## **REVISION LOG**

REVISION:001 DATE: 10/09/2020

# LOT 1009 - CARRIAGE GLEN

# Portico 2020 LH

**OPT. L-SHAPED SHOWER** SCALE: 1/8"=1'-0" ON 11x17, 1/4"=1'-0" ON 22x34

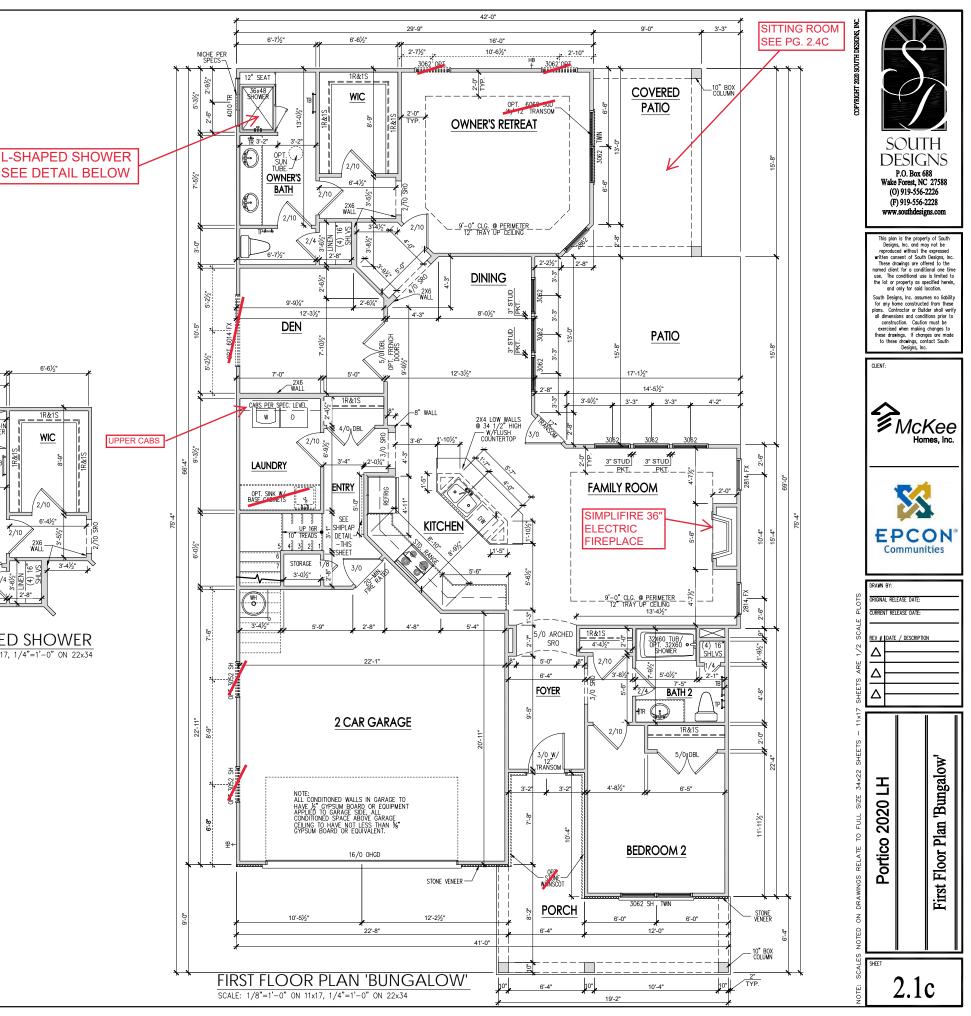
- ADD DELUXE KITCHEN OPTION RELOCATE NICHEIN L-SHAPED SHOWER IN OWNER'S BATH. CHANGE WAINSCOT TURNING CORNER AT PORCH TO OPTIONAL. REMOVED TOWEL RING IN BATH 3 VERIFY OPT. WE'T BAR IS BI' MOVE WET BAR JUNDER COUNTER REFRIG. TO RIGHT SIDE OF SINK. REMOVE DIMENSIONS FROM HVAC PLAIFORM.
